March 4, 2002

**SUBJECT: Temporary Design Bulletin C02-03
Effective March 1, 2002**

FDOT NOISE WALL PILE/POST CONNECTION OPTIONS – GENERAL NOTES (Page 1 of 1)

**NOISE BARRIER WALL.
(REV 2-20-02)**

FDOT NOISE WALL PILE/POST CONNECTION - OPTION NO. 1A (Page 1 of 2)

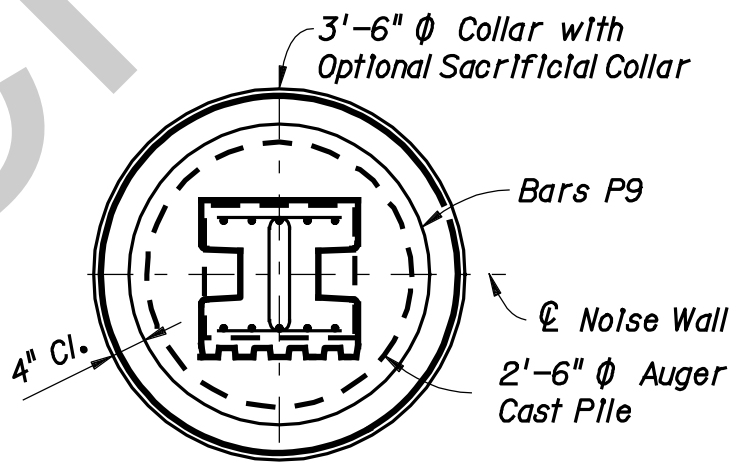
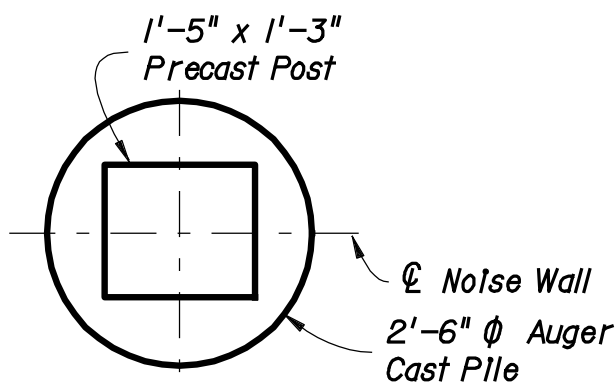
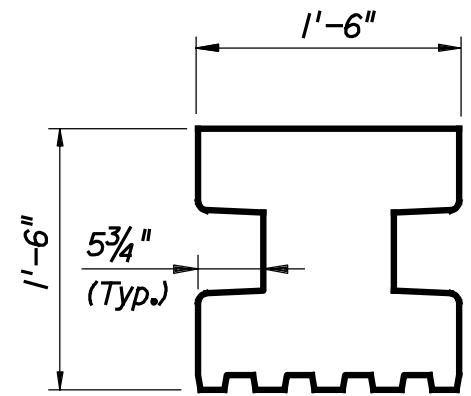
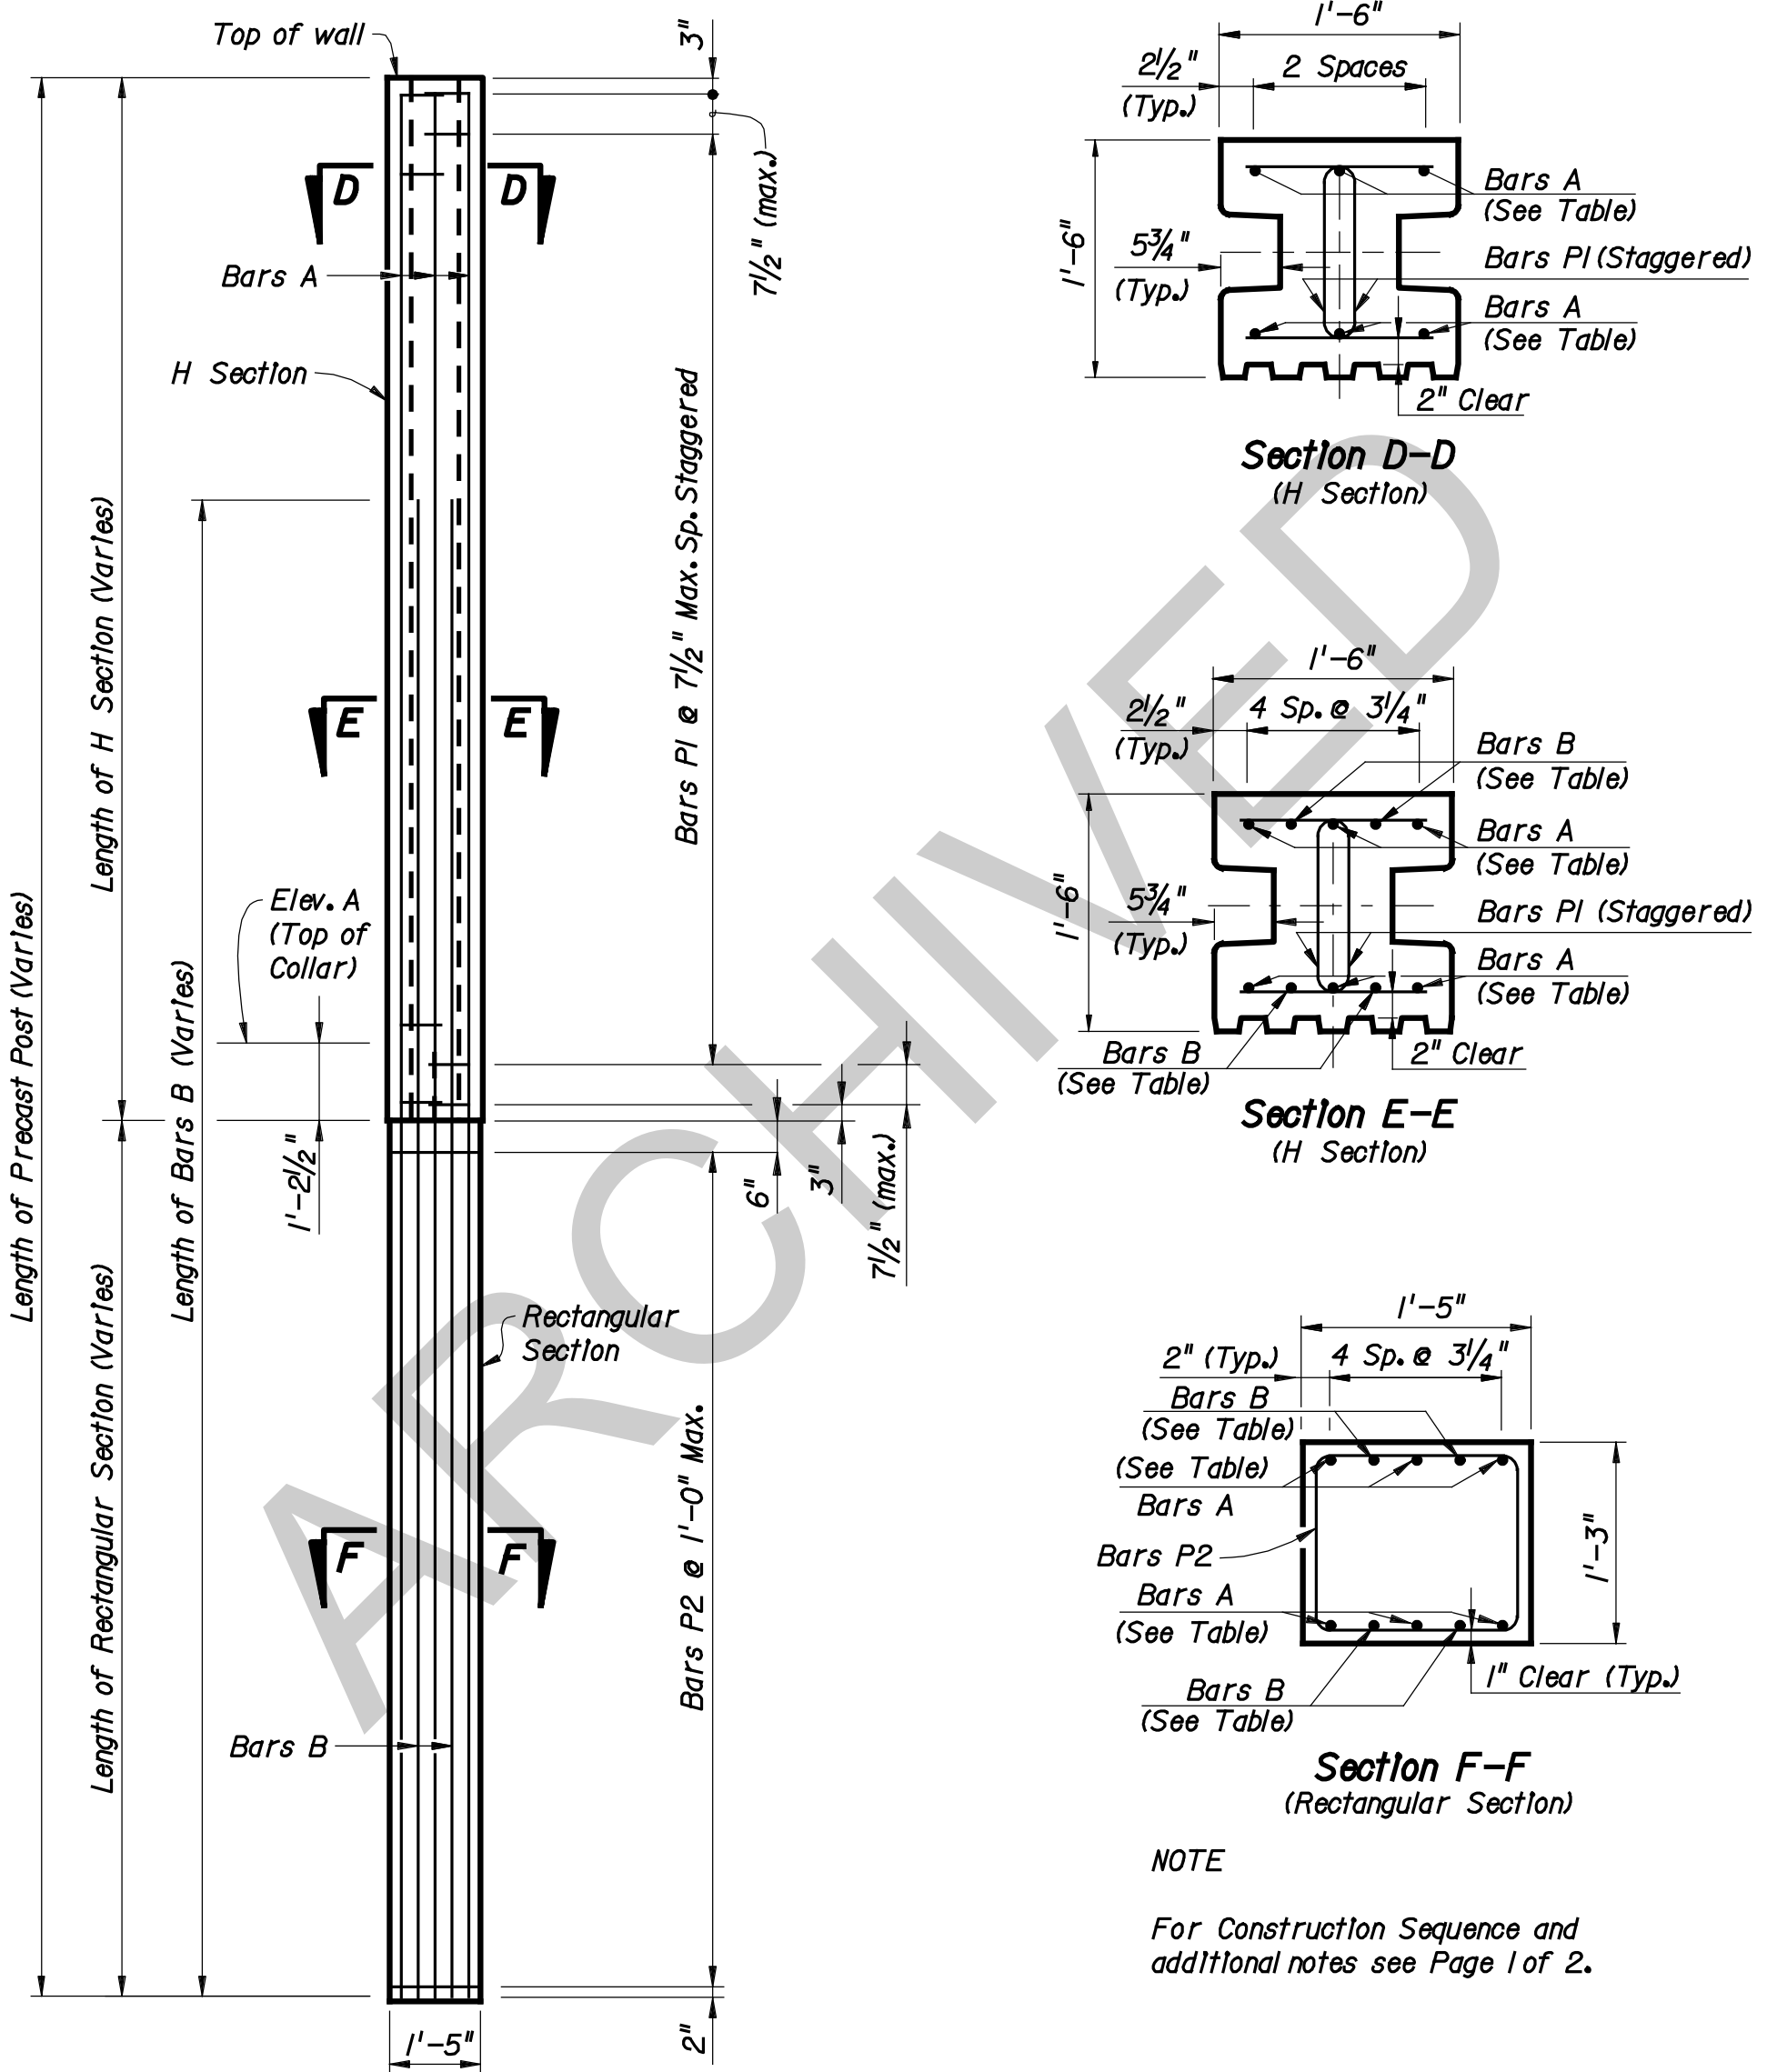
Requires casting concrete around the reinforcement cage extending below the bottom of the post, prior to setting the post into the auger cast pile. The rectangular section shown on page 2 of 2 of Option No. 1A may be replaced with the post H-section shown in Section E-E. If used, contractor shall provide additional P1 bars, as required, in lieu of the P2 bars shown for the rectangular section.

1. Cast the concrete H Post and a 1'-5" x 1'-3" rectangular pile around the rebar below the H Post section using 1" of cover. See post detail on Page 2 of 2.
2. Temporarily excavate to Elev. B in the vicinity of the post. Drill and cast a 2'-6" ϕ auger cast pile. Fill the augered hole to Elev. B
3. Place the sacrificial casing or collar form and collar reinforcement.
4. Construct a template to support and properly align the pile in the correct location in the 2'-6" ϕ hole.
5. Plunge the pile into the 2'-6" ϕ hole. The bottom of the H Post section (see section A-A) shall be 1'-2 1/2" below Elev. A (Top of Collar).
6. Finish the concrete to Elev. A (Top of Collar).
